ADDENDUM: **ONE**

PROJECT TITLE: **ENTRANCE GATE RENOVATIONS - GATES 2, 3, AND 4**
Francis Marion University
State Project No.: H18-9583-SG-E

FROM: McMillan Pazdan Smith Architecture - Columbia
Sanders Tate, Office Director
1316 Washington Street, Columbia SC 29201
state@mcmillanpazdansmith.com

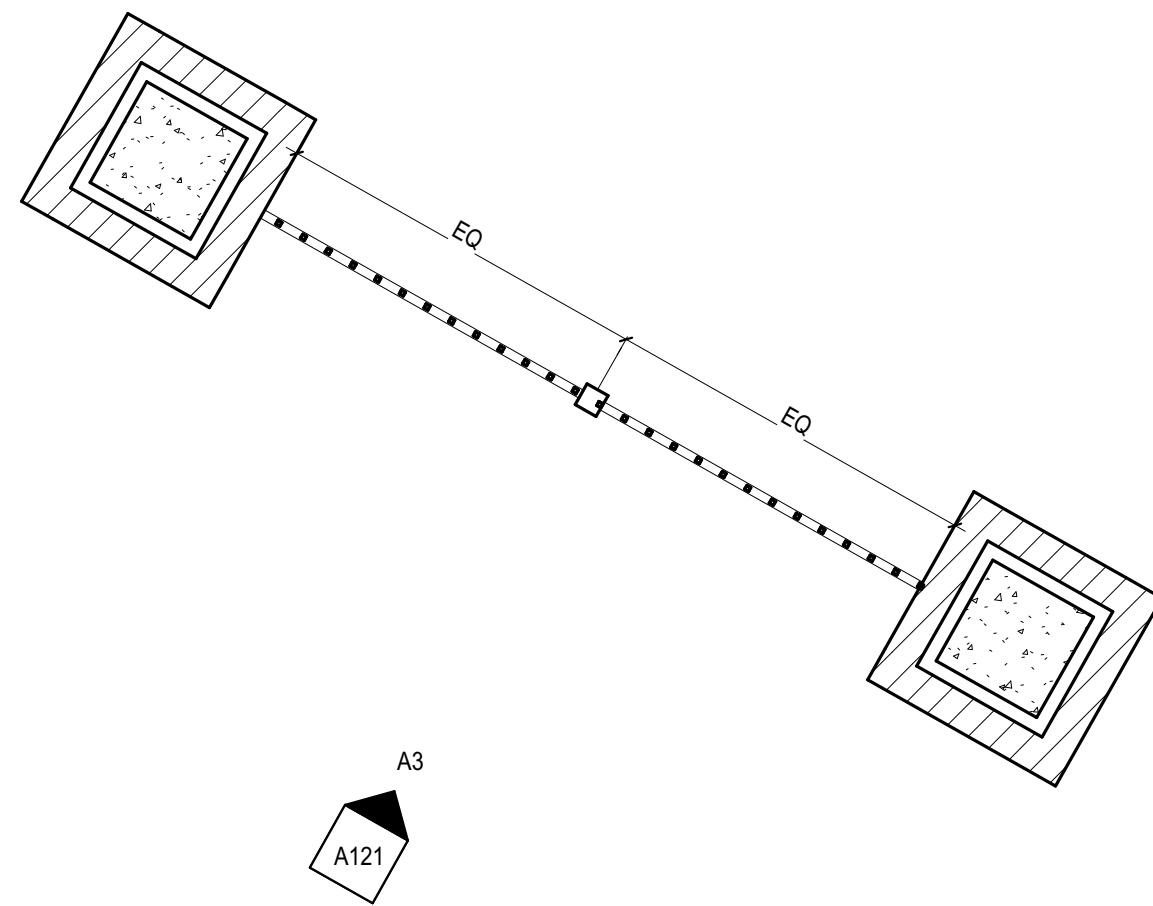
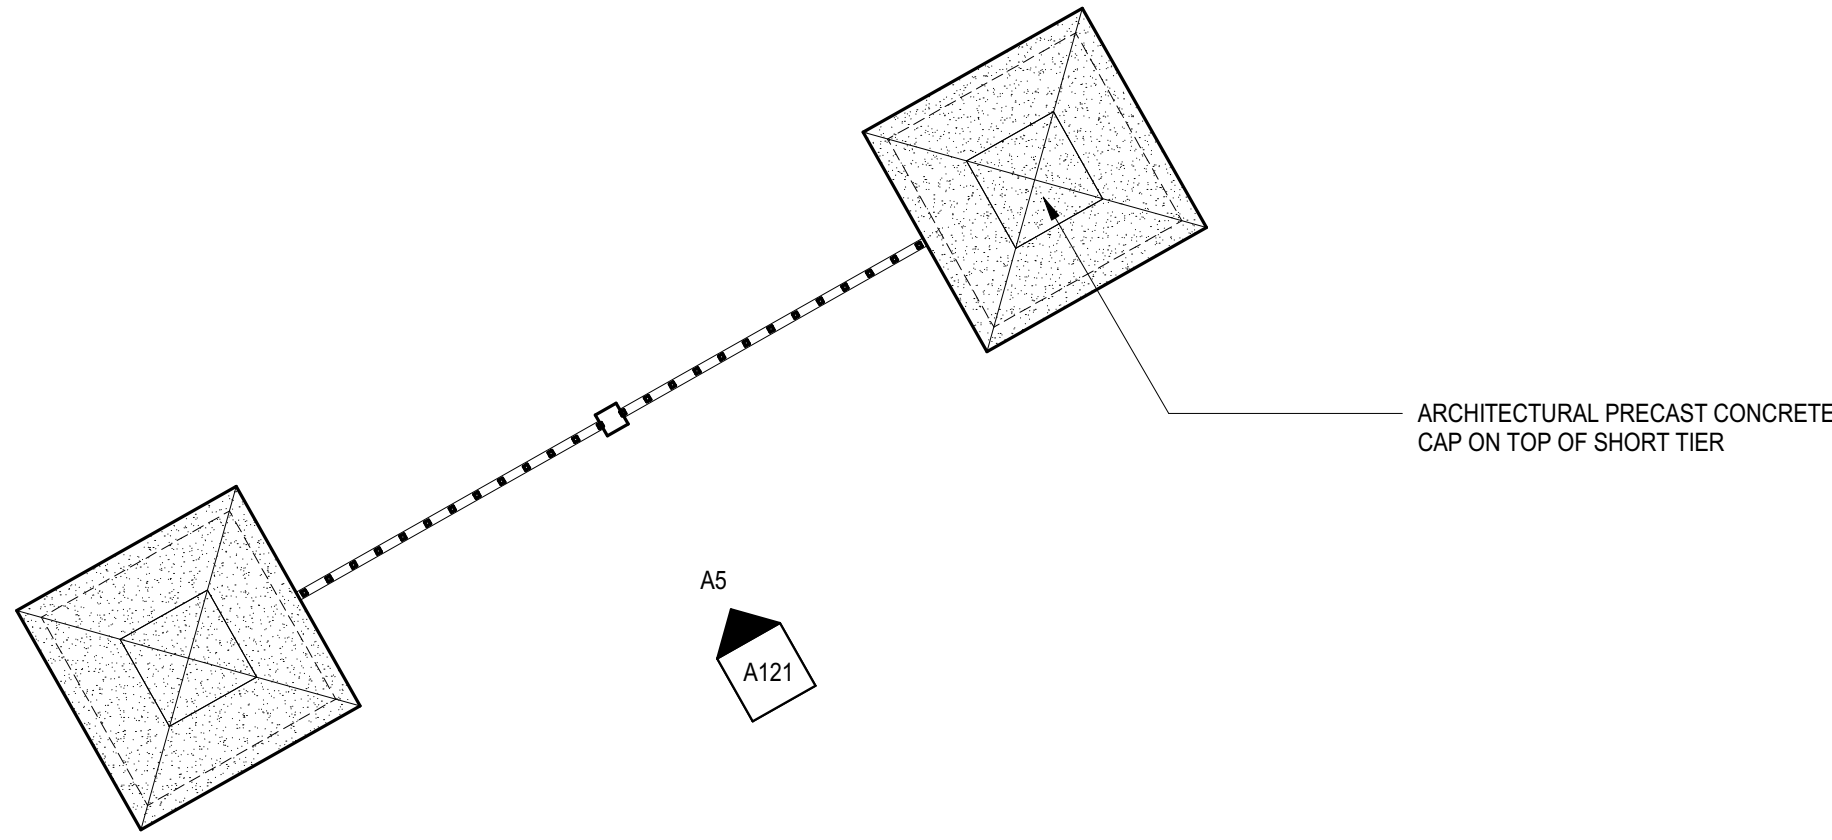
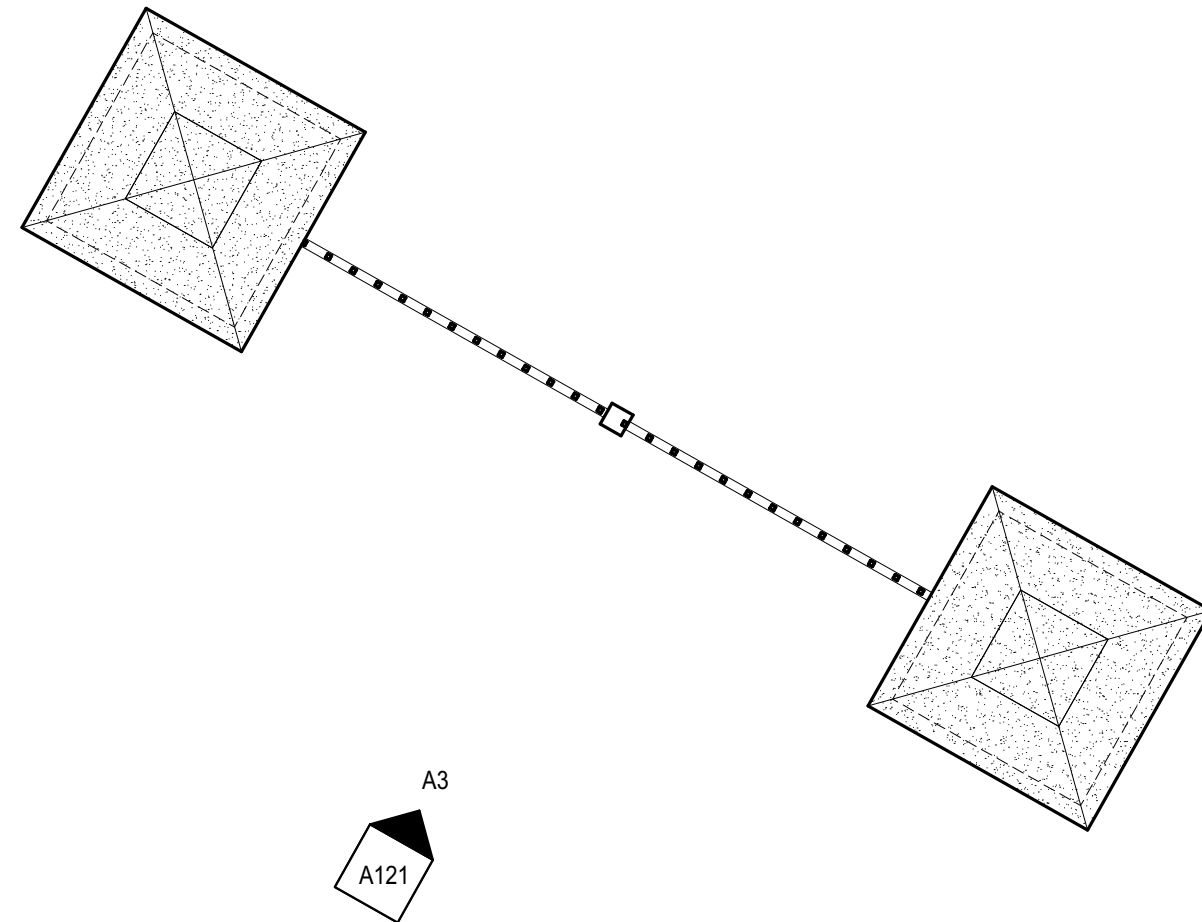
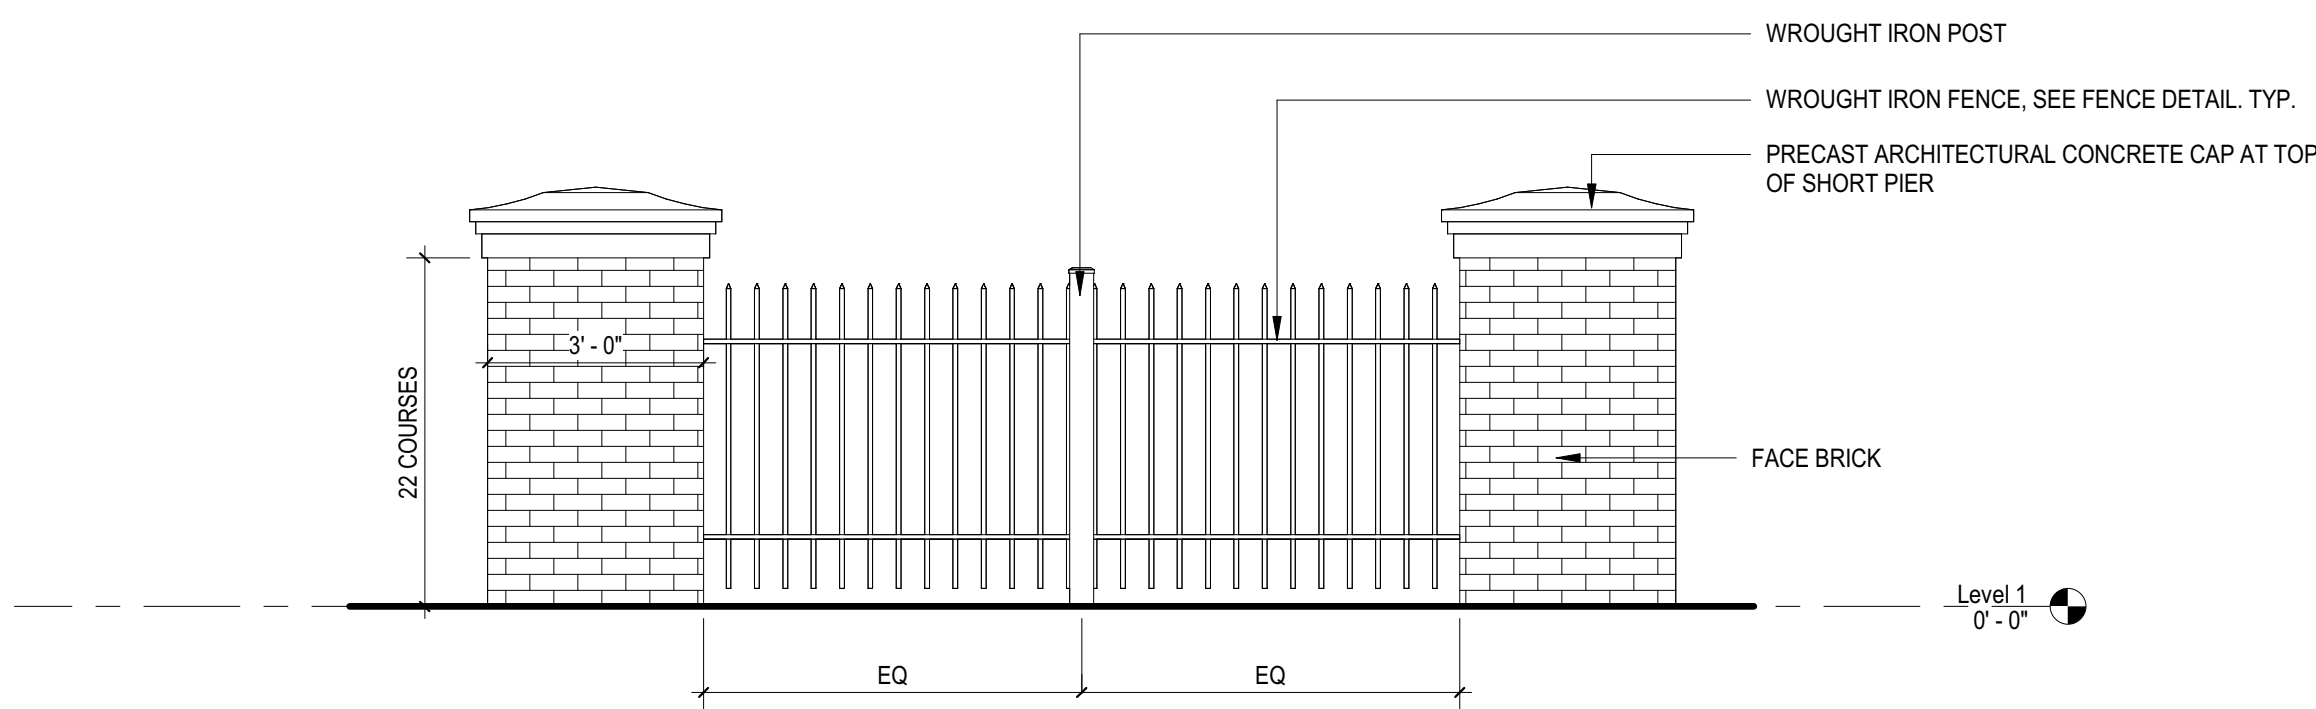
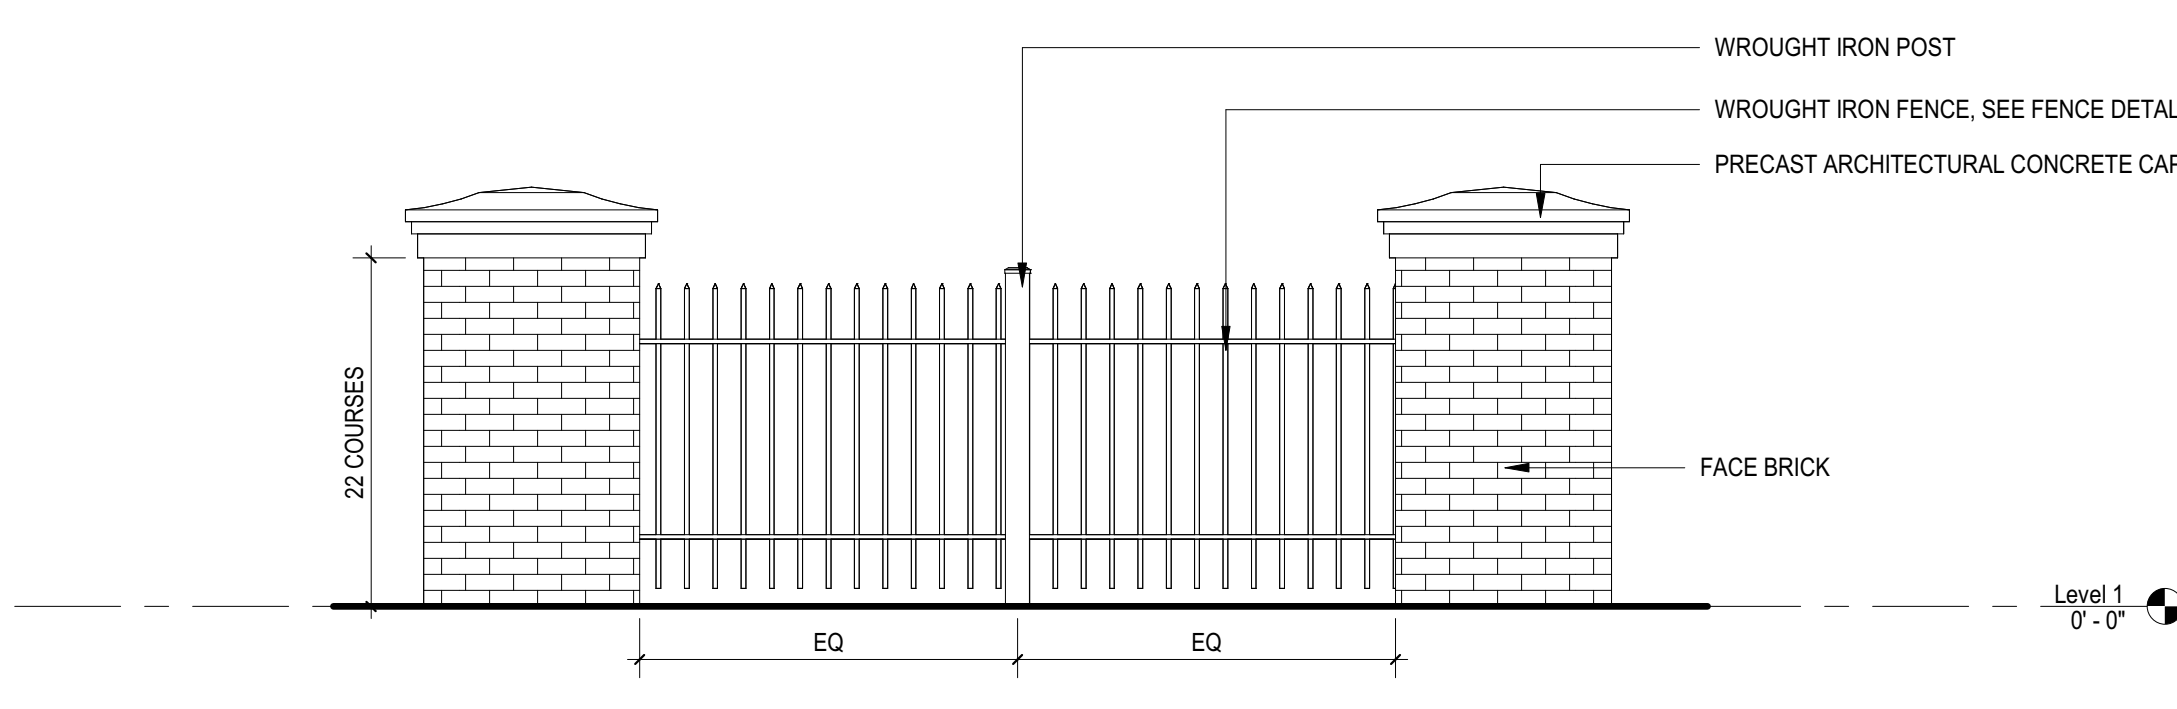
1. DRAWING A110 – GATE 1 PLAN AND ELEVATIONS:
Revise architectural precast concrete base to brick wall and height dimensions for all elevations.
2. DRAWING A120 – GATE 2 PLAN AND ELEVATIONS:
Revise architectural precast concrete base to brick wall and height dimensions for all elevations.
3. DRAWING A121 – GATE 2-2 PLAN AND ELEVATIONS:
Revise architectural precast concrete base to brick wall and height dimensions for all elevations.
4. DRAWING A130 – GATE 3 PLAN AND ELEVATIONS:
Revise architectural precast concrete base to brick wall and height dimensions for all elevations.
5. DRAWING A140 – GATE 4 PLAN AND ELEVATIONS:
Revise architectural precast concrete base to brick wall and height dimensions for all

C5
A331
ENLARGE PIER PLAN DETAIL
1" = 1'-0"

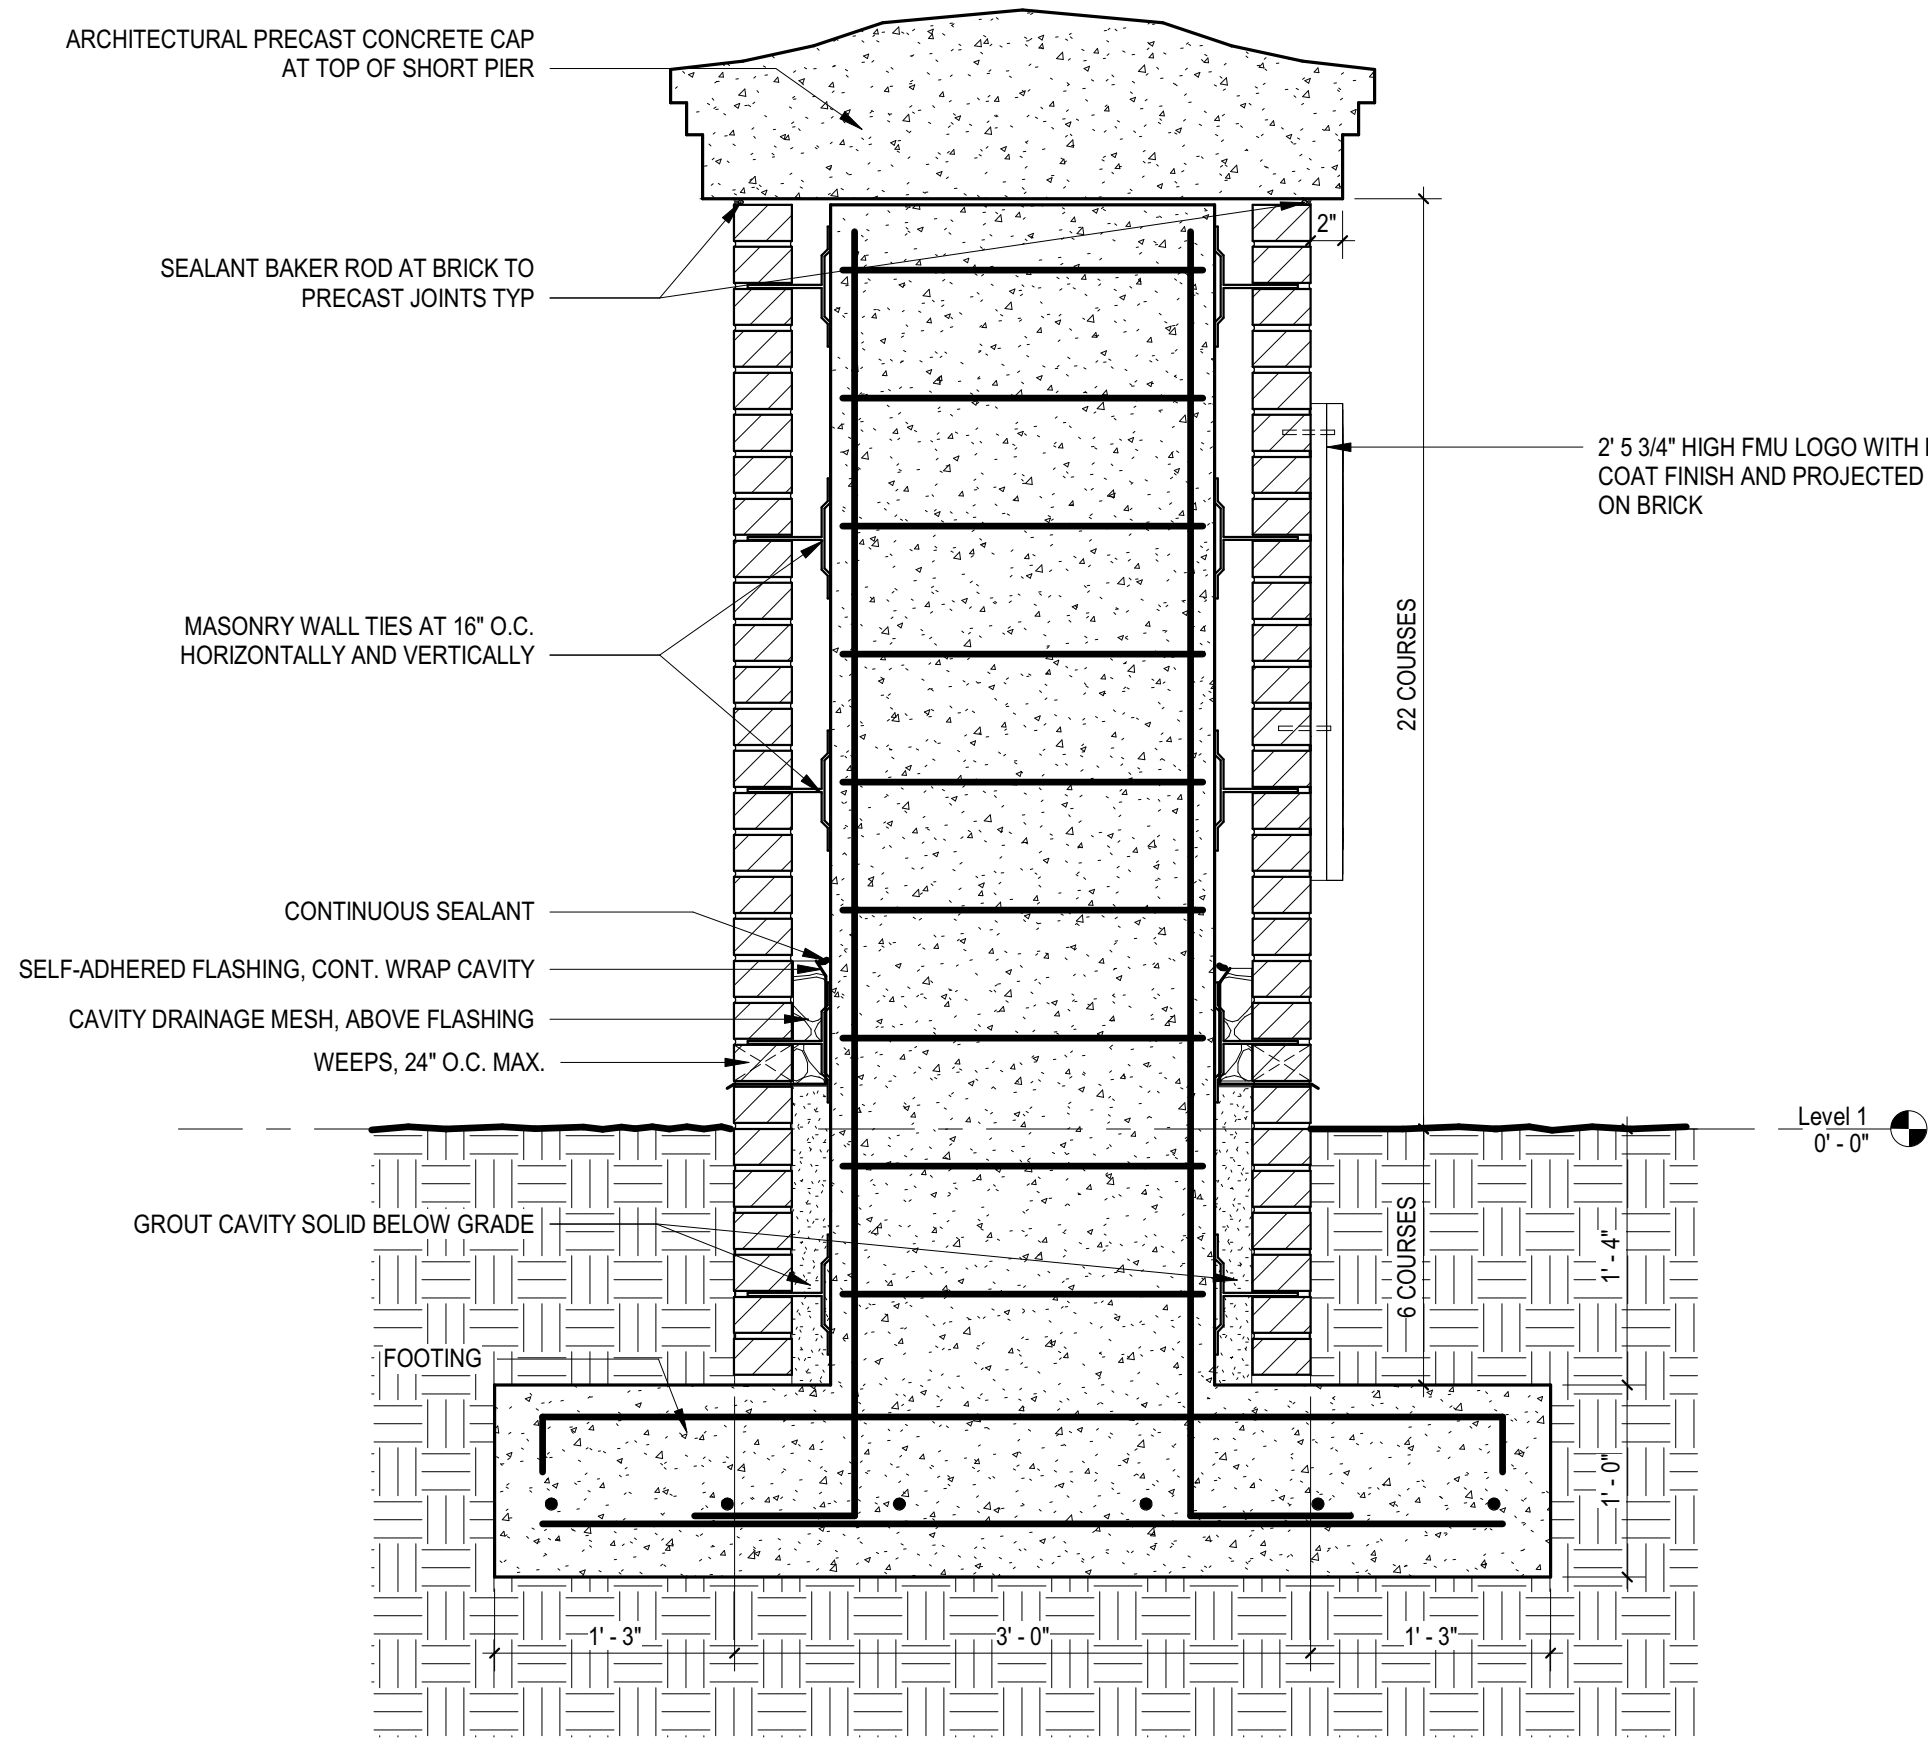
See attached new wall section sheet for revise details C5/A331, C3/A331, C2/A331, A5/A331, A3/A331, A2/A331.
